Memorandum [Public Version]

TO: THOMAS CMAR, EARTHJUSTICE
FROM: DR. TOMMY VITOLO, PATRICK LUCKOW, JOSEPH DANIEL, SYNAPSE ENERGY ECONOMICS
DATE: AUGUST 21, 2013
RE: COMMENTS REGARDING THE MISSOURI 2013 IRP UPDATES OF KCP&L AND GMO

Figure 1: Natural Gas Projections

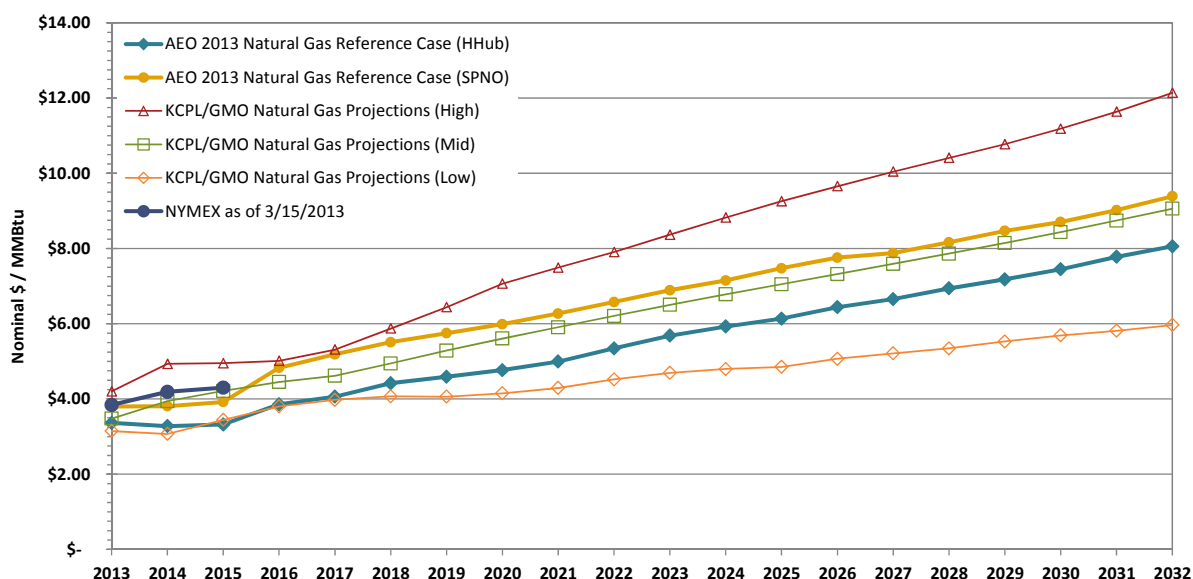
Figure 1 plots KCP&L's and GMO's high, middle, and low projections for the price of natural gas, as well as EIA's Annual Energy Outlook (AEO) 2013 price projection for natural gas at Henry Hub and for the electric utilities in the Southwest Power Pool North (SPNO) Electricity Market Module (EMM) region.⁴ While the companies' middle gas price projection closely tracks NYMEX, the high forecast is considerably higher than NYMEX in the 2013-2016 timeframe, and the low projection is considerably lower. While EIA expects the Henry Hub price to decline and the SPNO price to remain steady through 2015,

KCP&L/GMO's projections show the company expects the price to have a relatively steady price escalation over the next two decades. After 2016, the AEO price projections and the KCP&L/GMO middle price projection follow similar trajectories. In 2032, the companies' middle projection is closer to AEO SPNO, despite KCP&L/GMO's 2013 price being closer to the 2013 AEO Henry Hub price. It appears that the KCP&L/GMO near-term forecasts have far too wide a range given the robustness of NYMEX futures.

Figure 2: Coal Price Projections

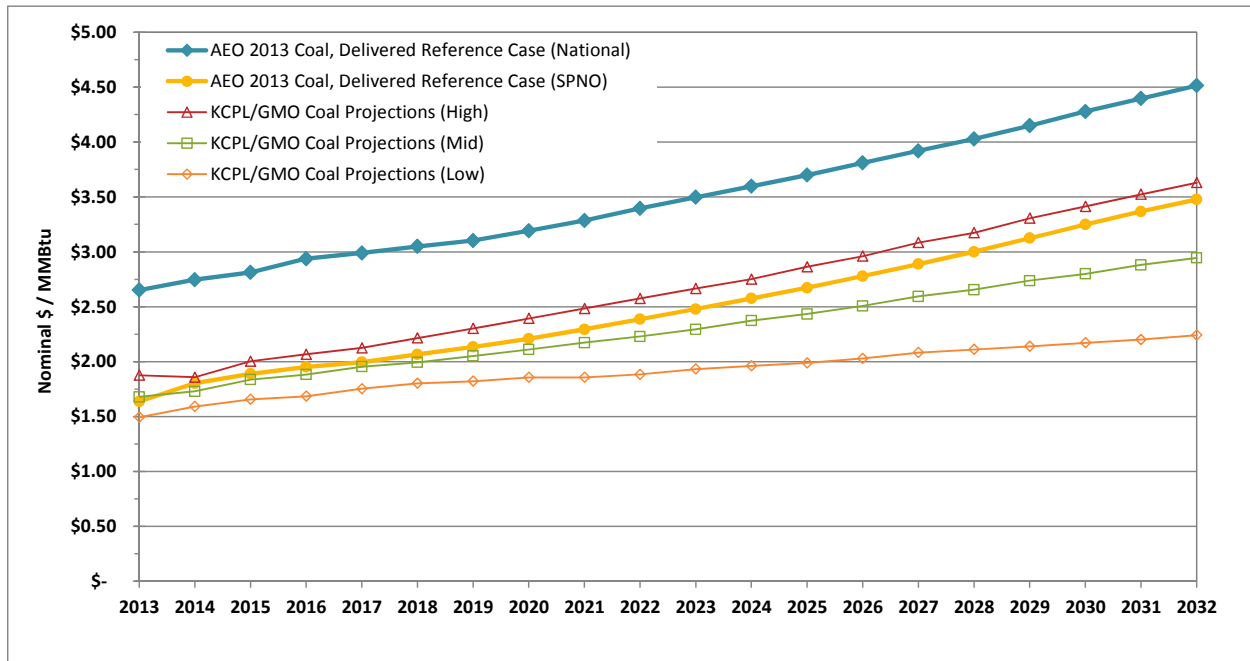
KCP&L and GMO state that their coal price projections reflect forecasts from EIA, Energy Ventures Analysis, JD Energy, SNL Financial, and Hanou Energy Consulting.⁵ Figure 2 plots all three of KCP&L/GMO's coal projections (high, middle, and low), along with the AEO price projections for the national average and SPNO.^{6,7} All of KCP&L/GMO's projections remain below the national average for delivered coal prices. Only the companies' high projection for coal prices is above average delivered coal prices for the SPNO region. KCP&L/GMO's low projection for coal prices in 2013 is [REDACTED] percent lower than its middle projection ([REDACTED] versus [REDACTED]) while the high projection for 2013 is more than [REDACTED] percent higher than its middle projection ([REDACTED] versus [REDACTED]).

Mine mouth prices have tended to be quite stable with a slight upward trend. Spot market coal prices have exhibited some volatility, but the majority of coal for electric generation is typically acquired under long-term contracts. Given this, it is odd that KCP&L and GMO project that much uncertainty in coal prices for the year 2013 and other near-term years. In the short run, KCP&L/GMO's high price projection shows an initial price decline; it is the only coal price projection that has year-on-year price decline. Qualitatively, the AEO national delivered coal price, the AEO SPNO regional delivered coal price, and KCP&L/GMO's middle coal price projection all have similar price escalations, though the companies' is slightly lower. In conclusion, the large spread both between high and medium projections and between medium and low projections in the short term raises concerns.

Figure 3: CO₂ Price Projections

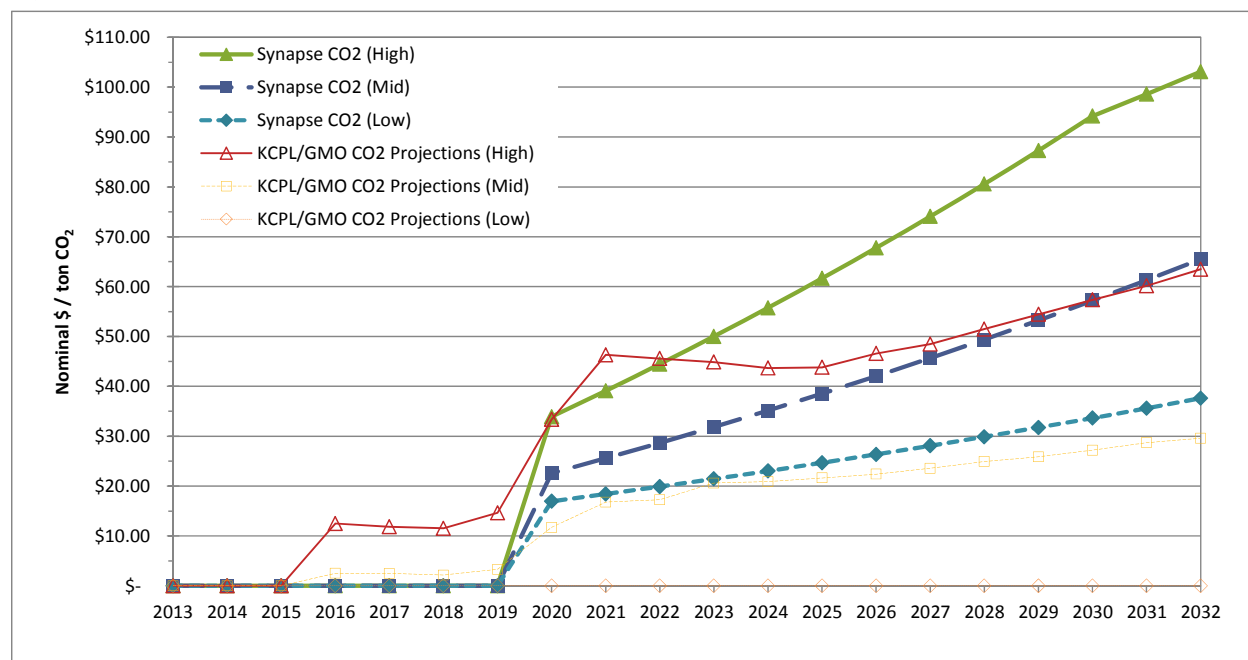
Figure 3 plots KCP&L/GMO’s high, middle, and low carbon price projections, along with Synapse’s high, middle and low carbon price projections. Synapse’s low projection has a carbon price of \$16.95 starting in 2020 and escalating to \$37.62 in 2032.⁸ KCP&L and GMO, on the other hand, use a [REDACTED] per ton CO₂ for the low carbon price forecast, which the companies’ Monte Carlo analysis designates having a 25 percent probability of coming to fruition.⁹ This represents a prediction that there is a one-in-four chance that [REDACTED] (by way of tax, trading scheme, etc.) at either the state or federal level at any point between now and 2032. We believe this to be a rather poor assumption. President Obama announced his plan to cut emissions of carbon dioxide earlier this year.¹⁰ The White House specifically noted the power sector is responsible for nearly 40 percent of carbon pollution, and the President directed the EPA to revise its proposal for carbon pollution standards for new power plants, to issue proposed standards, regulations, or guidelines addressing carbon pollution at existing

KCP&L/GMO’s middle projection closely follows Synapse’s low projection, though by 2032—the end of the study period—the companies’ middle projection has a lower CO₂ price than Synapse’s low projection of \$37.62. An unusual property of KCP&L/GMO’s CO₂ projection is that it has consecutive years with a declining carbon price when reported in nominal dollars. This happens within two blocks of time for KCP&L/GMO’s high projection, and for one block of time for the companies’ middle projection.

KCP&L/GMO’s results for carbon pricing call into question the methodology that was used to generate its forecasts. KCP&L and GMO state that their carbon price projections reflect forecasts from CERA/Global Insight, PIRA, Energy Ventures Analysis, Wood Mac (sic), JD Energy, and Synapse, but the companies have not provided any documentation or explanation of how its forecast was derived.¹² Moreover, the companies’ assumption in their middle price forecast of a falling nominal price in some multi-year periods does not align with the dozens of proposals that have been suggested by utility owners or policymakers, nor does assigning a 25 percent chance of [REDACTED] carbon price at any time in the next 20 years. Given President Obama’s direction to the EPA to complete regulations

of carbon dioxide emissions during his term in office, it would be wise and prudent for KCP&L and GMO to reconsider their high, middle, and low CO₂ forecasts.

Figure 4: Annual RAP DSM potential for KCP&L, reproduced from Navigant DSM Study, page 50

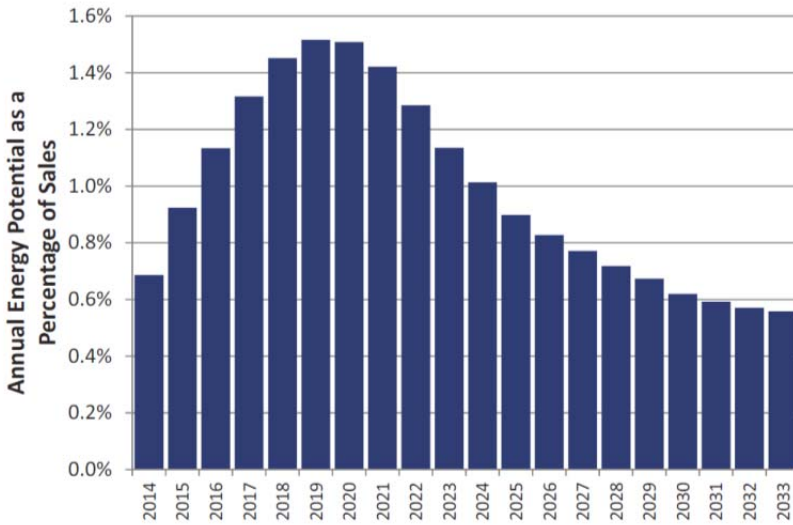
Figure 4 reproduces the Navigant study's annual DSM energy potential for KCP&L's Missouri operations. Per the study, "potential ramps up over the first several years, peaks in about 2020, and tails off in the later years as the market for energy savings saturates and approaches its equilibrium value."¹⁴ According to Navigant, this tail remains positive for several reasons, including the addition of building stock and the rise of avoided costs, which make more measures economic. While the annual energy savings potential peaks and declines, the cumulative potential will continue to grow throughout the study period, provided that energy efficiency measures are replaced at the end of their useful life. The Navigant study's annual DSM energy potential for GMO reaches similar conclusions.

Figure 5: Annual DSM energy for RAP and MEEIA-RAP alternatives

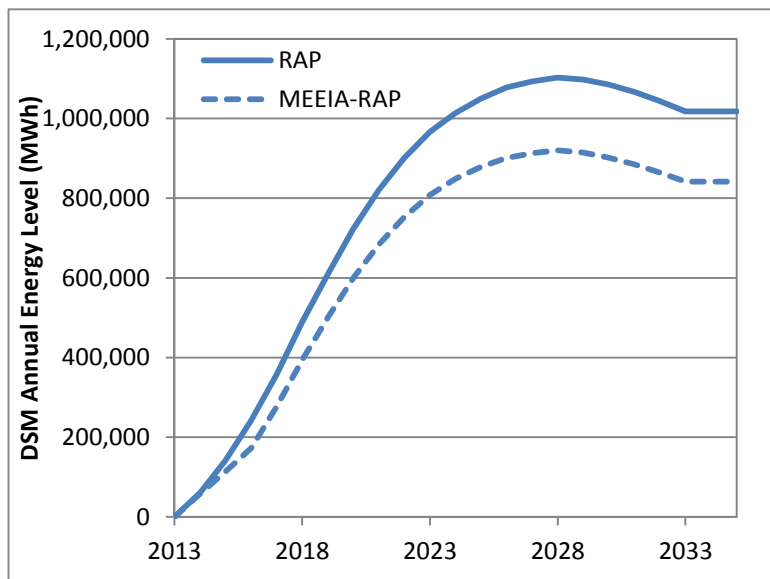
KCP&L’s adjusted MEEIA-RAP forecast is compared to RAP in Figure 5. The reduced spending over a few early years cascades forward, resulting in substantially less cumulative DSM energy savings over the study period. This difference results in the substantial difference in costs and rates of the two plans discussed above.

Figure 6: DSM capacity from Navigant Report and KCP&L’s plans

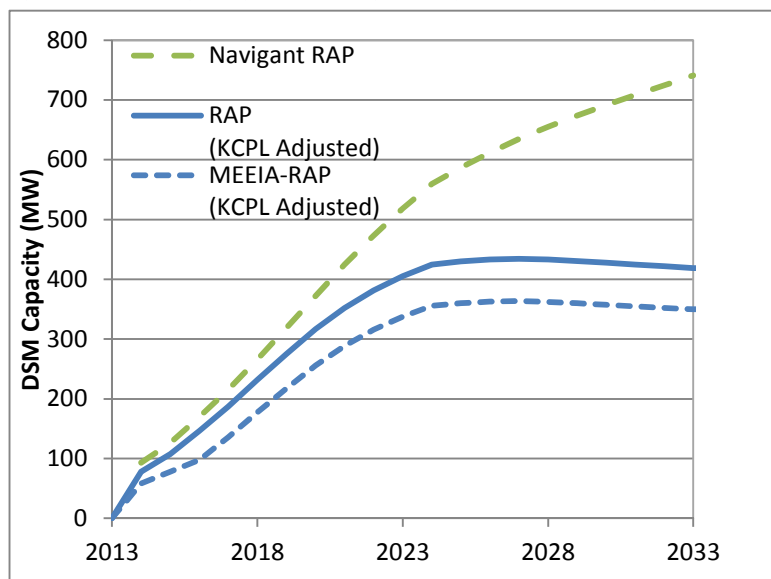
In addition to being an essential low-cost energy resource, DSM also provides demand savings in the form of peak reductions. The cumulative demand savings potential from the Navigant study (Appendix L) grows every year, as shown in Figure 6, eventually rising to a total of 741 MW for KCP&L in the RAP scenario, including energy efficiency (EE), demand response (DR), and combined heat and power (CHP). KCP&L’s Stakeholder Report (Appendix B) shows a peak DSM capacity of only 432 MW for the RAP scenario, and 363 MW for the MEEIA-RAP scenario. After the peak year in 2026, the capacity savings associated with DSM flattens and subsequently declines. It is unclear why this decline exists, given the Navigant study’s finding of a steadily increasing potential out to 2033. While Navigant shows annual savings may decline as the market becomes more saturated (as indicated for energy in Figure 5), cumulative capacity should continue to increase.

Figure 7: Annual generation at Lake Road 4/6 after conversion to gas/oil, plan AICGA, mid load, gas, and CO₂ assumptions⁵⁰

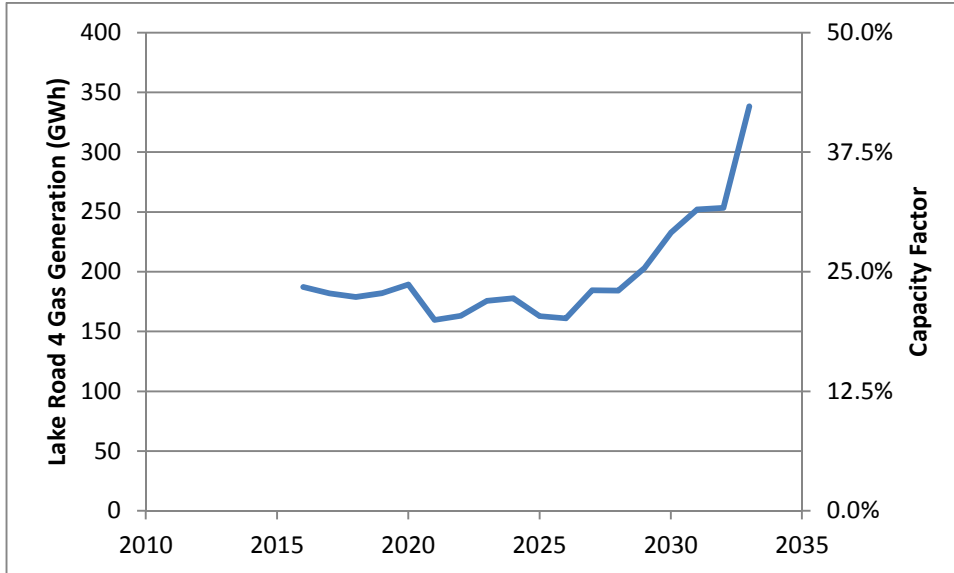
GMO did not provide its model input files to stakeholders for review. In the absence of a detailed explanation in the 2013 IRP Update, the unexpectedly high capacity factor for Lake Road 4/6 in the company's modeling results (reproduced in Figure 7) generates several questions about the modeling methodology. The Lake Road MEGA study asserts a heat rate of [REDACTED] Btu per kWh after conversion, which is poor in comparison to the company's other coal and gas units.⁴⁹ Perhaps the Lake Road 4/6 heat rate input was improperly modeled by a failure to correctly adjust the properties associated with the fuel change. How does the Lake Road 4/6 dispatch cost compare to market prices? It is important to understand why GMO models the unit operating as frequently as it does in light of its relatively poor heat rate. GMO is pursuing a more expensive plan by not retiring Lake Road 4/6, but this level of operation raises questions about the model inputs directly related to Lake Road 4/6.
